CITY OF CONWAY, ARKANSAS HISTORIC DISTRICT COMMISSION

HISTORIC DISTRICT COMMISSION

November 28, 2022

2024 Weems Street - New Single-Family Residence

1 PROPOSED SITE PLAN
1" = 10'-0"

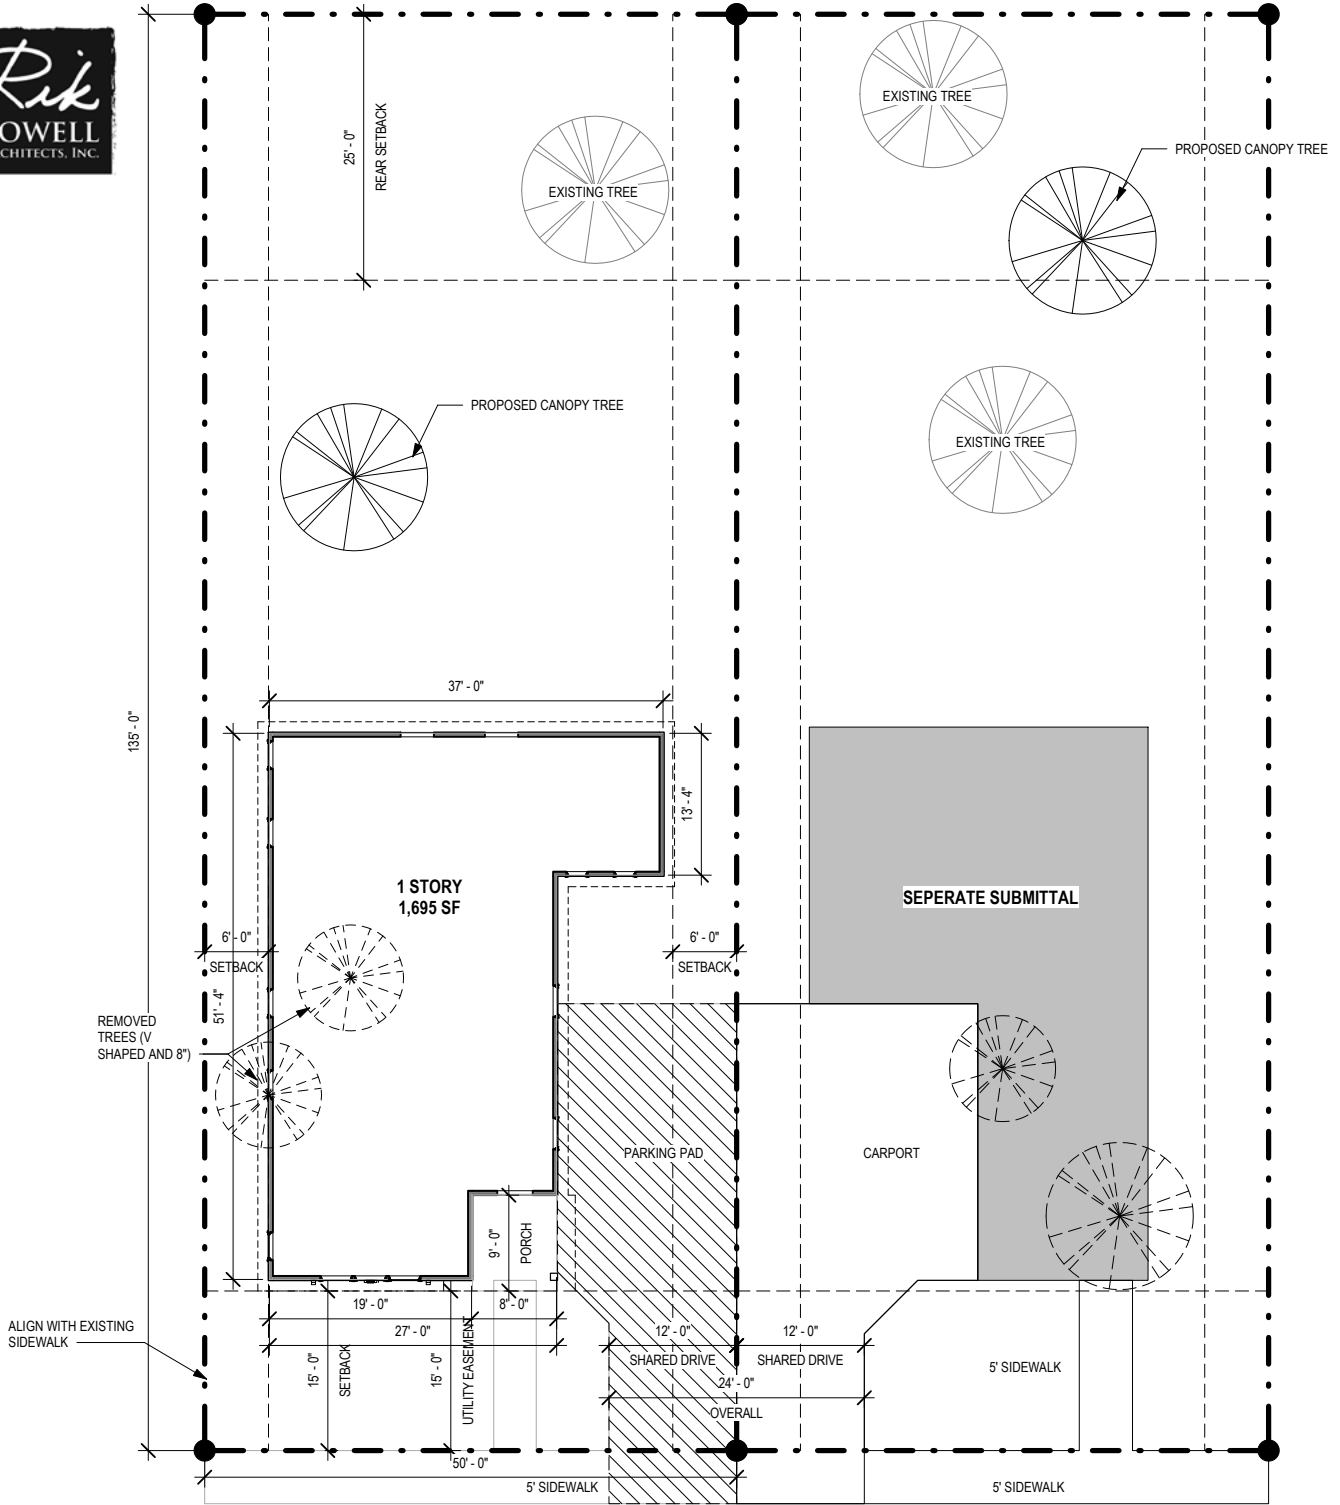
While shared driveways are encouraged, the driveway sharing is meant to reduce the overall width of the driveway. As proposed, two 12' driveways are to be constructed in parallel. A single smaller driveway would likely not function well due to the short length of the driveway. As such, a separated 12' driveway is recommended for this property with 2' green buffers on the west and east sides of the driveway. The on-street space in front of the house may count as the second required parking space.

There are no existing sidewalks on the site. A 5' sidewalk with a 6.5' greenspace setback is required along each frontage. The applicant is proposing a walkway from the front door to the sidewalk.

It appears two significant trees will be impacted by the construction. One canopy tree is required for the front yard. Plans should indicate the planting of canopy trees.

1. Planting of 1 canopy tree in the front yard is required.
2. Require all windows be one-over-one design and feature wide trim.
3. Require fascia and soffits to be finished with wood or wood equivalent construction (Hardie® siding).
4. HVAC equipment be placed in a manner to minimize its visibility from the street.
5. Driveway shall not exceed 12' width and shall feature 2' green buffers on either side.
6. Provide a crawlspace, taller slab, other mechanism to provide the slab an "elevated" appearance that is more compatible to the area.
7. Submit revised drawings to the Planning Director for approval prior to release of the COA.

STORYBOOK RESIDENCE - 2024 WEEMS ST.
EXTERIOR ELEVATIONS

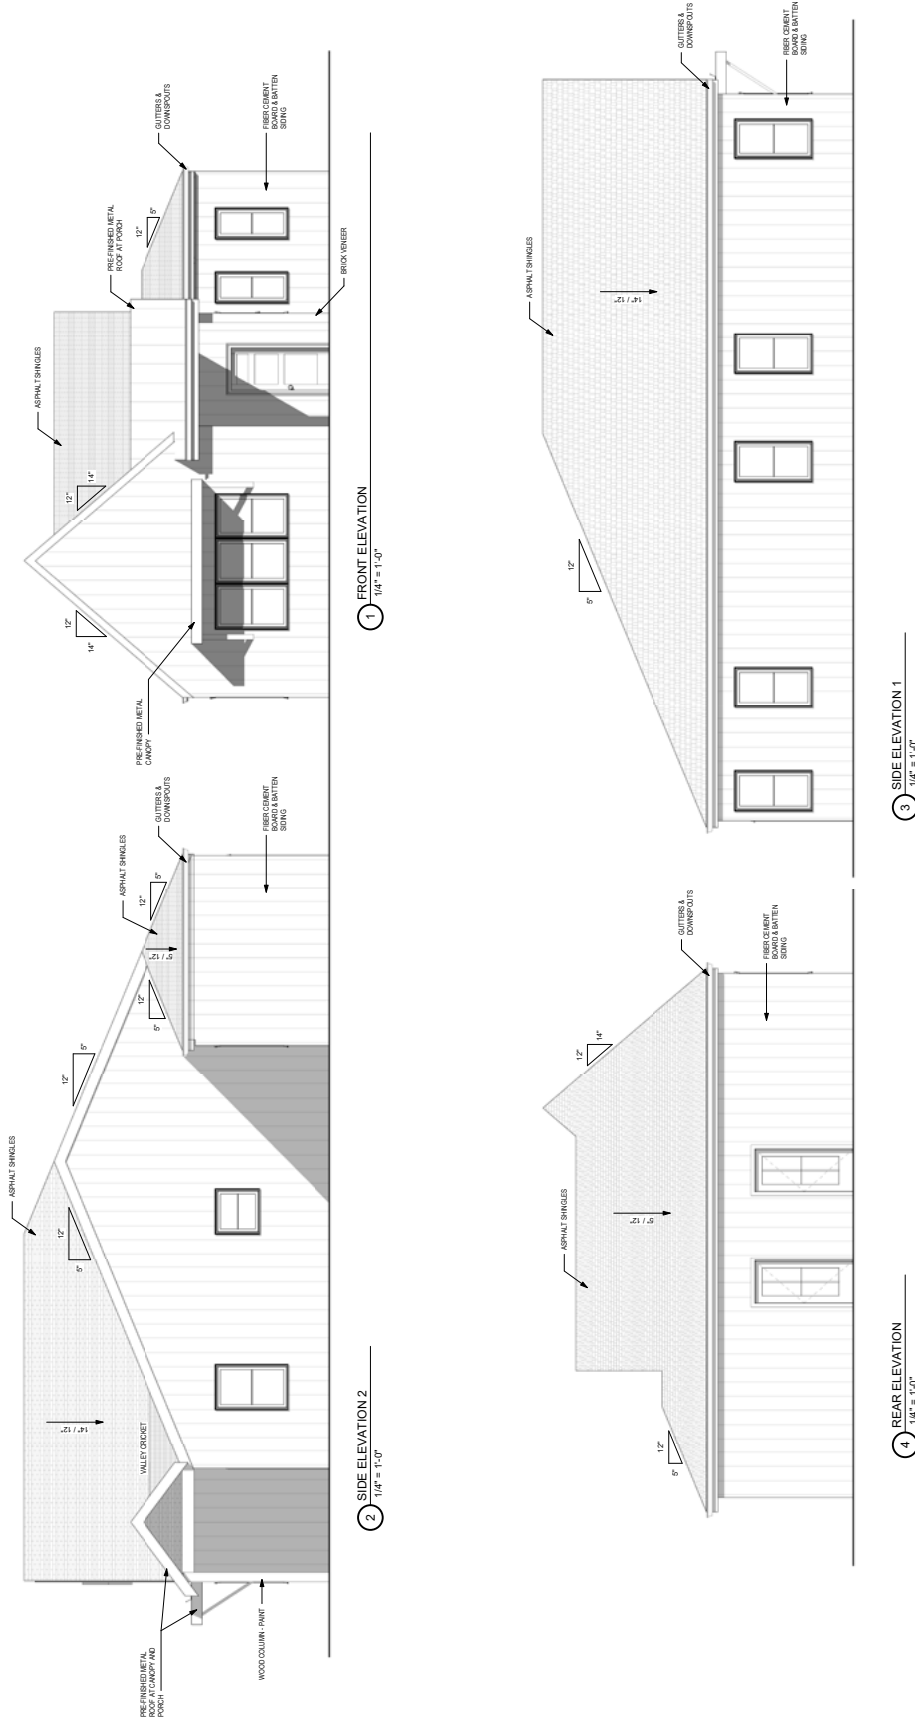
An open front porch with a 9' depth is proposed. The proposed vinyl windows are appropriate and feature wide trim and are one-over-one.

The regulations call for traditional awnings when used. The proposed awning is more a commercial style awning. The commission should consider this issue when reviewing the application.

The applicant is proposing board and batten siding. The slab construction of the foundation does not appear to have a compatible appearance. Recommend requiring a crawlspace or a taller slab to have a more compatible appearance.

1 FIRST FLOOR PLAN
1" = 10'-0"

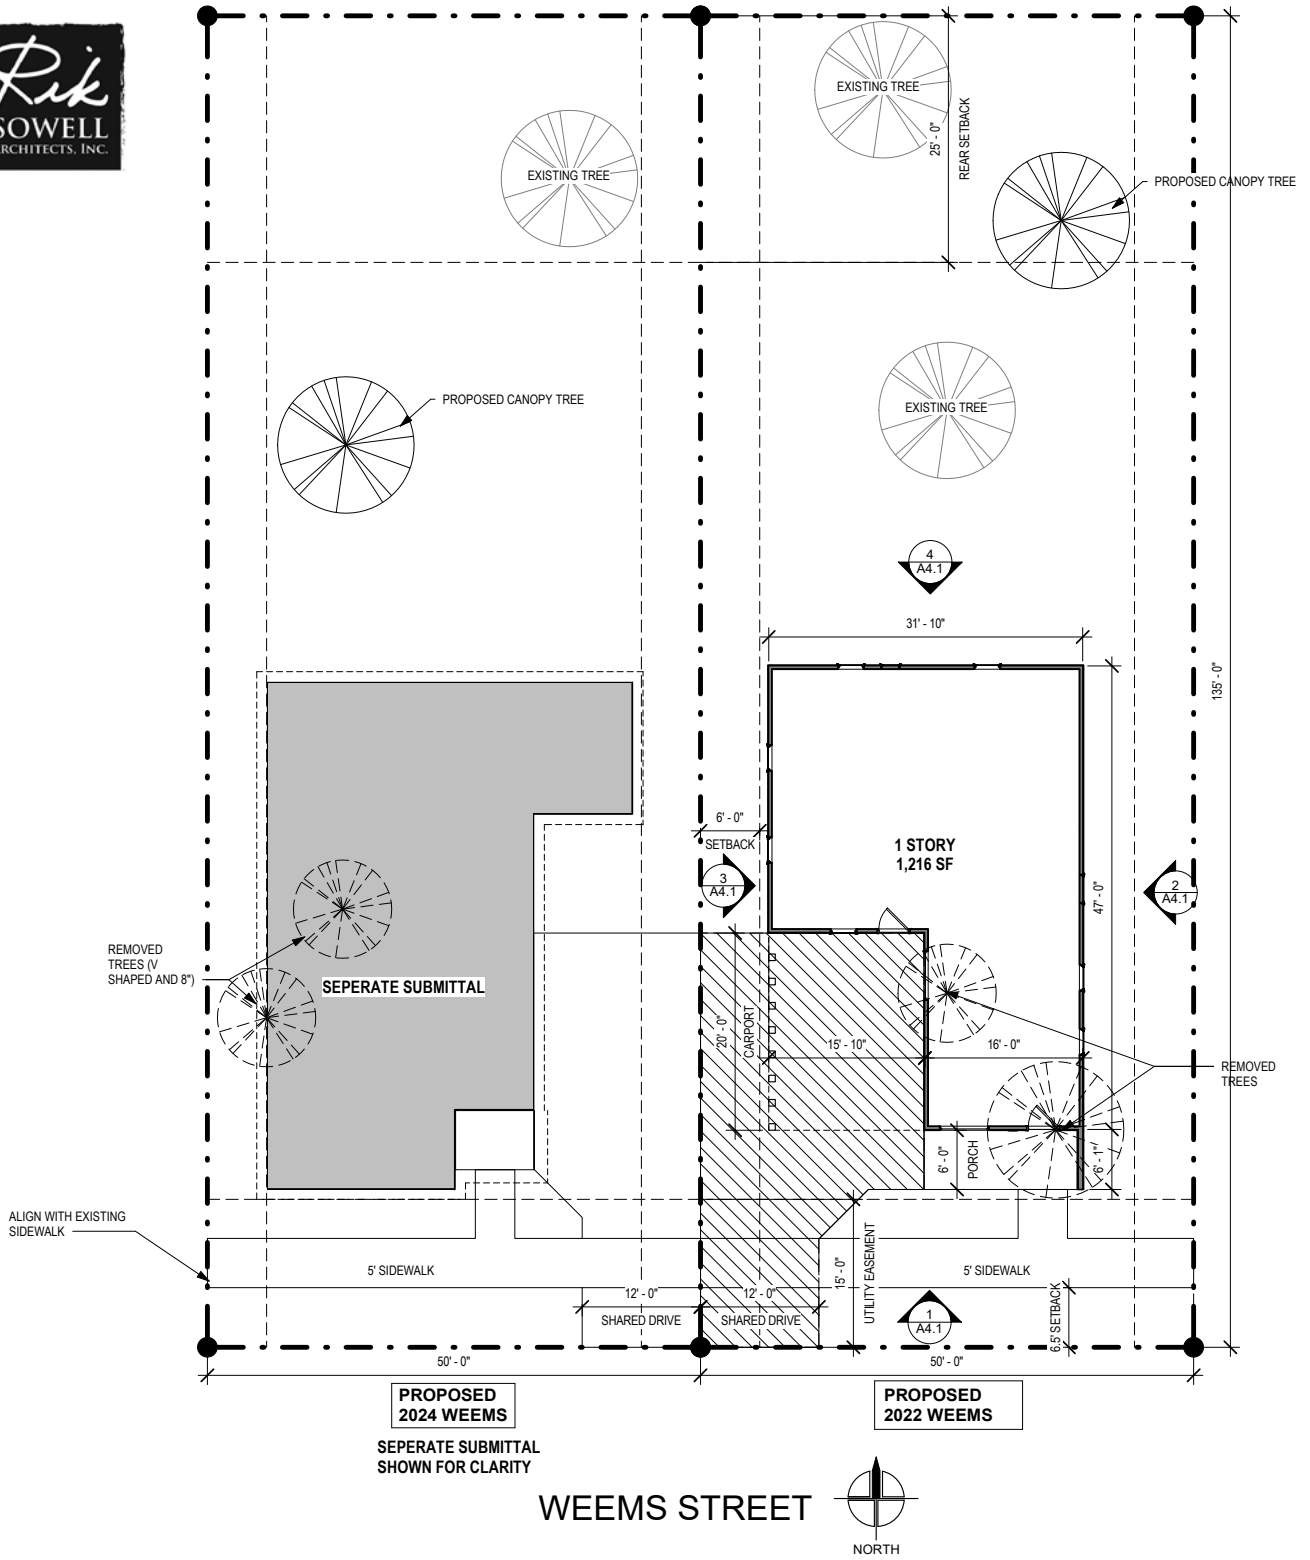
While shared driveways are encouraged, the driveway sharing is meant to reduce the overall width of the driveway. As proposed, two 12' driveways are to be constructed in parallel. A single smaller driveway would likely not function well due to the short length of the driveway. As such, a separated 12' driveway is recommended for this property with removal of 6' paved area west of the covered carport.

There are no existing sidewalks on the site. A 5' sidewalk with a 6.5' greenspace setback is required along each frontage. The applicant is proposing a walkway from the front door to the sidewalk.

It appears two significant trees will be impacted by the construction. One canopy tree is required for the front yard. Plans should indicate the planting of canopy trees.

1. Planting of 1 canopy tree in the front yard is required.
2. Require all windows be one-over-one design and feature wide trim.
3. Require fascia and soffits to be finished with wood or wood equivalent construction (Hardie® siding).
4. HVAC equipment be placed in a manner to minimize its visibility from the street.
5. Driveway shall not exceed 12' width with paving allowed west of the covered carport.
6. Correct sidewalk location on plans.
7. Provide a crawlspace, taller slab, other mechanism to provide the slab an "elevated" appearance that is more compatible to the area.
8. Modify the solid canopy wall to provide more transparency with slats or other elements.
9. Submit revised drawings to the Planning Director for approval prior to release of the COA.

STORYBOOK RESIDENCE - 2022 WEEMS ST.
EXTERIOR ELEVATIONS

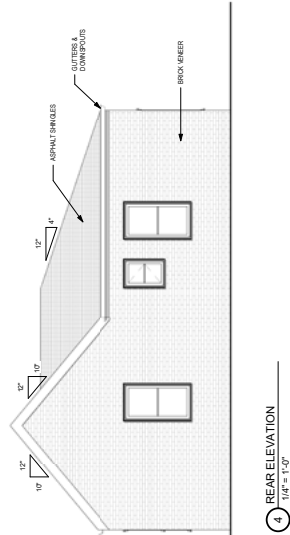
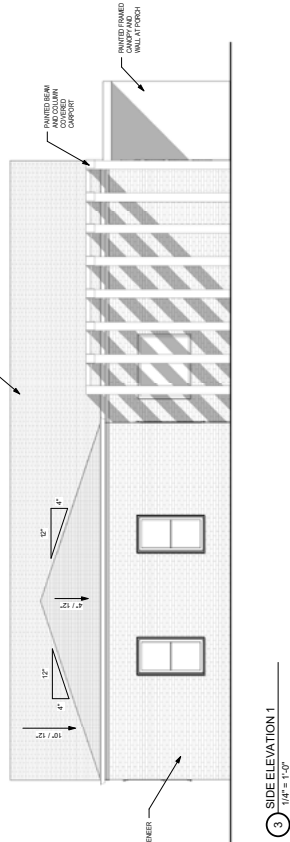
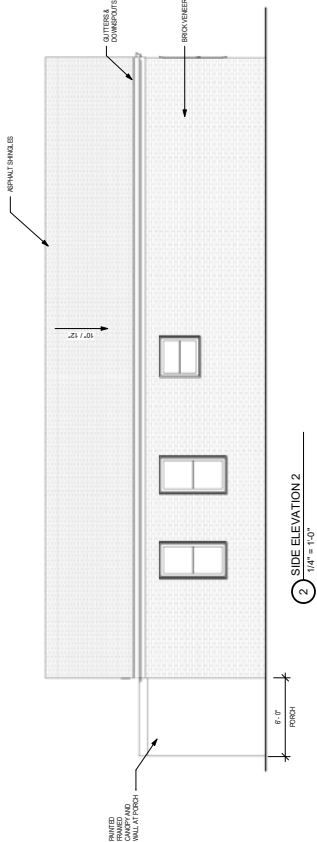
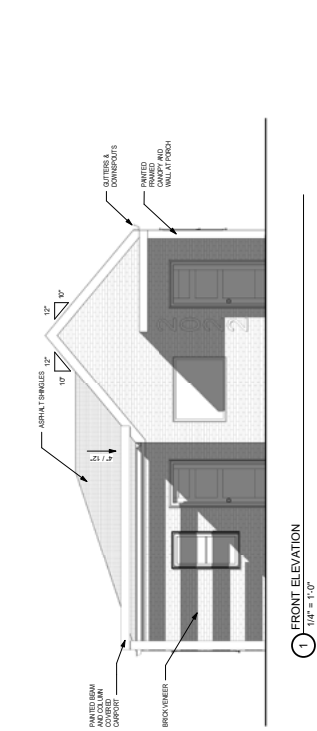
A partially covered front porch with a 6' depth is proposed. The proposed vinyl windows are appropriate, but should feature wide trim. The regulations call for traditional awnings when used. The proposed canopy wall is non-traditional. If allowed, the wall should feature some level of transparency on the vertical wall to breakup its starkness

The applicant is proposing brick siding. The slab construction of the foundation does not appear to have a compatible appearance. Recommend requiring a crawlspace or a taller slab to have a more compatible appearance.

1 PROPOSED SITE PLAN
1" = 10'-0"

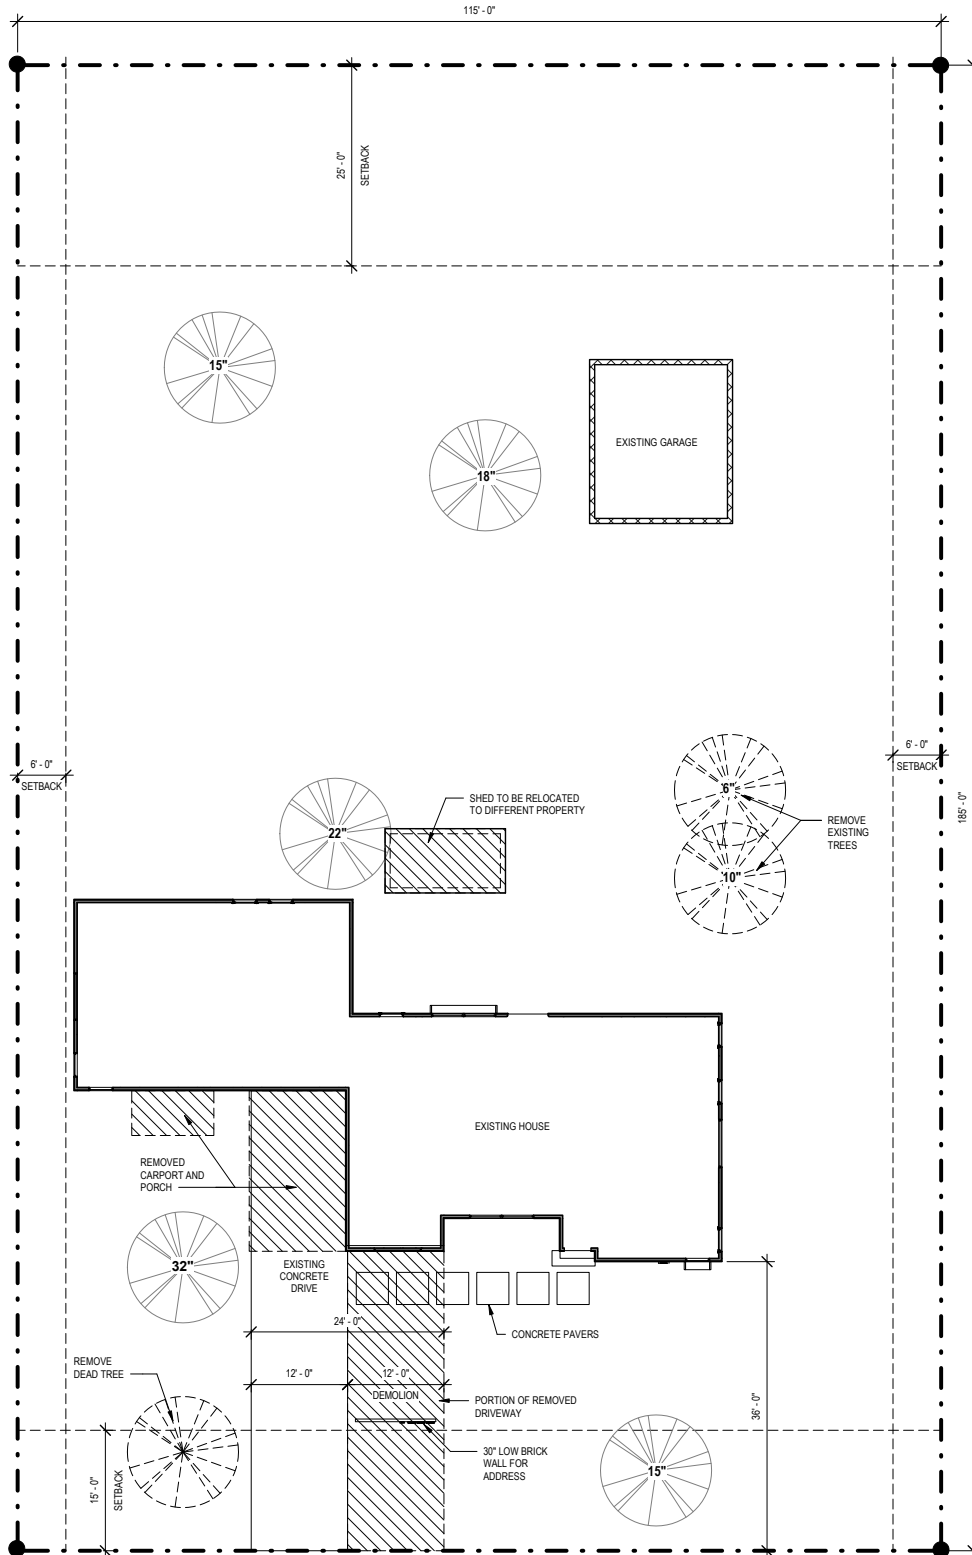
The applicant is proposing to reduce the existing 24' driveway down to 12' wide. The driveway appears appropriate.

The applicant is proposing a 30" tall brick wall to place the address numbers. The regulations only allow walls up to 18" tall.

1. The front address wall be limited to 18" height.
2. Require that the same window proportion percentage be maintained on the structure, no boxed windows be allowed, and any window replacements follow a pattern of one-over-one vertical oriented windows consistent with the existing window on the eastern end of the structure.
3. Require fascia and soffits to be finished with wood or wood equivalent construction (Hardie® siding).
4. HVAC equipment be placed in a manner to minimize its visibility from the street.
5. Submit revised drawings to the Planning Director for approval prior to release of the COA.

1 FRONT ELEVATION

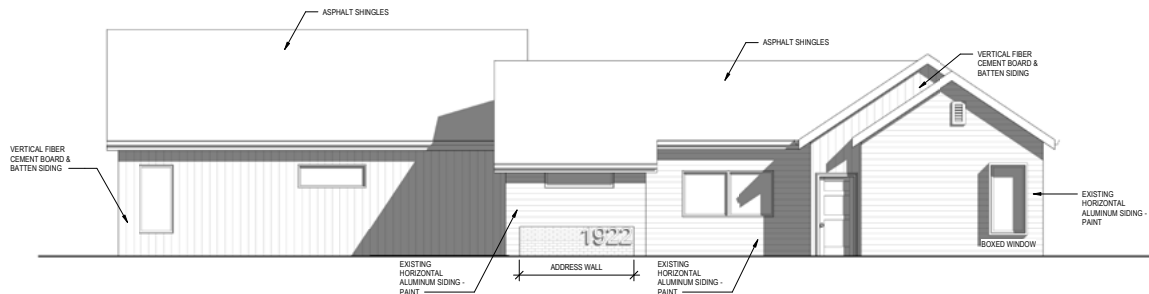
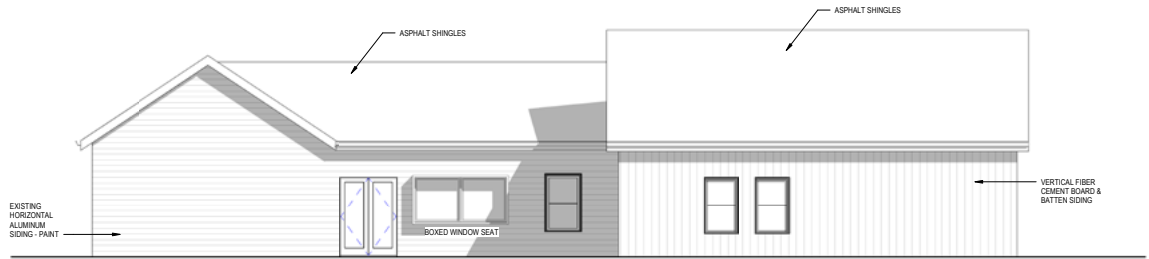
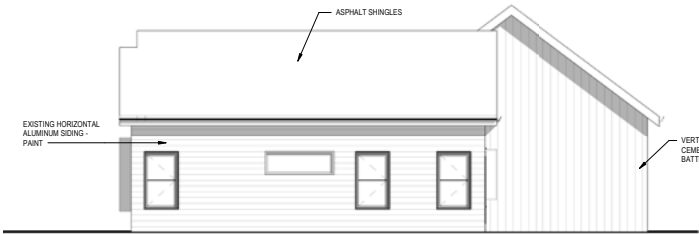
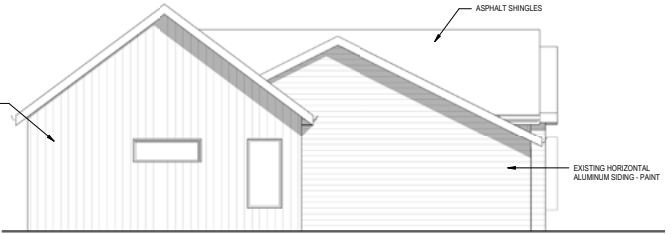
The front façade will be composed 14% windows and openings. At least one door opening is being removed as part of the work. Two small horizontal windows are being used in place of existing small windows. Almost all proposed windows are single-pane windows. The proposed window plan is not compatible with the structure's design, or the general pattern of development seen on the block. Recommend requiring that the same window proportion percentage be maintained on the structure, no boxed windows be allowed, and any window replacements follow a pattern of one-over-one vertical oriented windows consistent with the existing window on the eastern end of the structure.

The surrounding area has a somewhat cohesive theme of styles which are primarily traditional in nature. The proposed modifications don't appear consistent with the surrounding area's traditional forms and patterns.

The applicant is proposing select replacement of the existing metal siding with vertical board and batten fiber cement panel. This material usage is appropriate.
